**NAPA LOGISTICS PARK**  
NAPA, CALIFORNIA

**Land Use Compatibility and Airspace Analysis Report**

Prepared for  
**Orchard Partners, LLC**  
By  
**Mead & Hunt, Inc.**

**Napa Logistics Park Review**

Exhibit 2

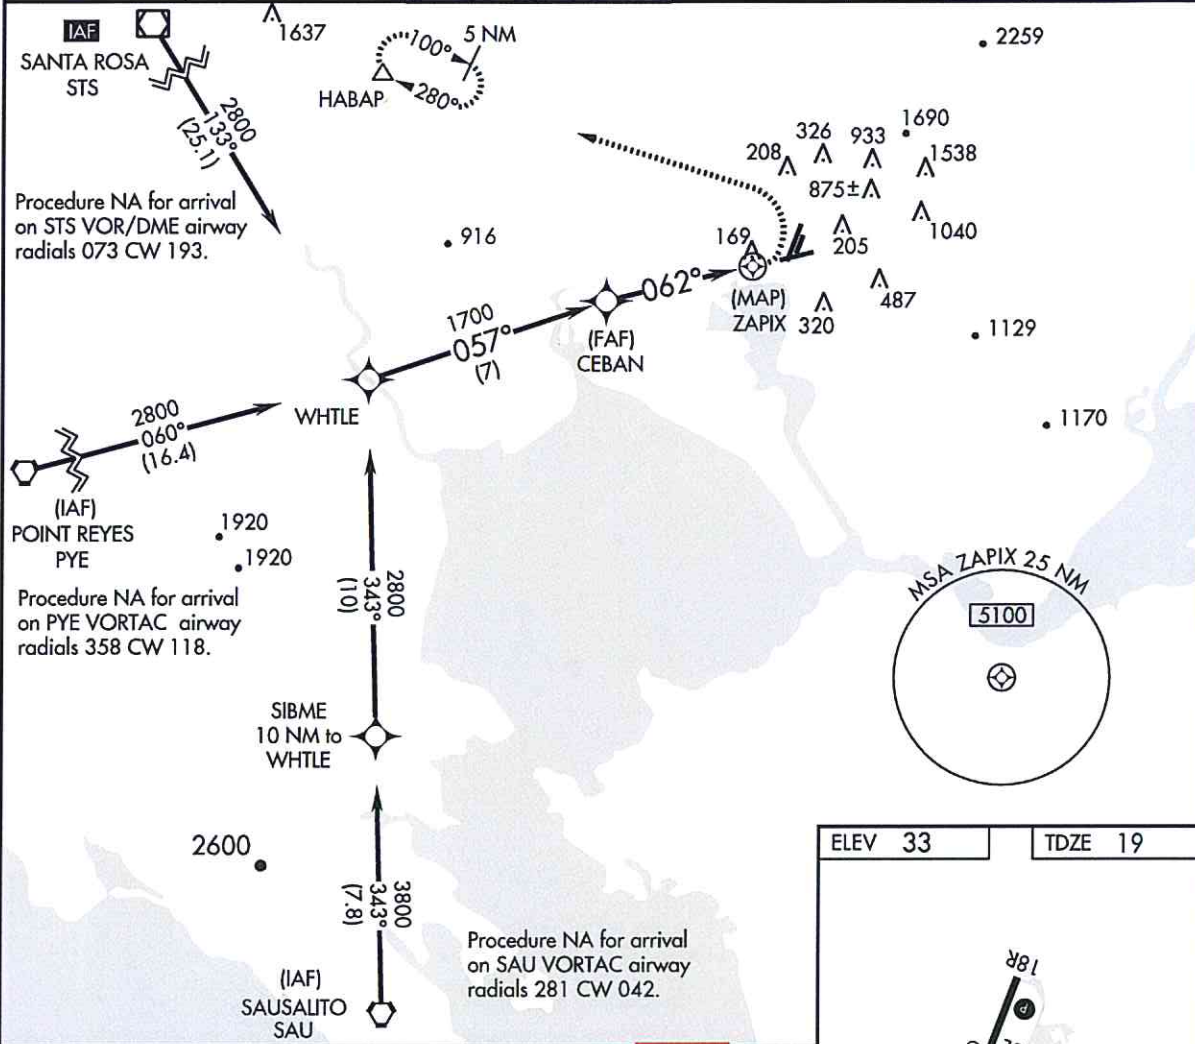
FAA airspace surfaces that could potentially affect the Project are illustrated in **Exhibit 2**. These surfaces are explained in more detail below. Airspace analysis looks at the elevations of the proposed structured in

feet above mean sea level (MSL). Preliminary elevations of each building corner are identified in **Exhibit 2**. However, the developer indicated these are not final elevations and final building heights may be 100 feet above ground level. The airspace analysis assumes final building heights at 100 feet above finished grade.

Airspace surfaces on **Exhibit 2** include those associated with the existing runways and instrument approach capabilities at the Airport, and the future runways and instrument approaches illustrated on the Airport Layout Plan that is going through FAA review as of April 2015. The general conclusion is that the Project does not penetrate any of the approach and departure airspace surfaces.

The DS is a trapezoid shape that begins at the end of the runway length usable for takeoff and extends along the extended runway centerline and with a slope of 1 unit vertically for every 40 units horizontally (40:1). As shown in **Exhibit 2**, the Project is not below or near either DS, therefore the Project will not impact the DS.

The Project is clear of critical airspace surfaces. The site is located under the Part 77 horizontal surface, but will not penetrate it as shown in Table 2.
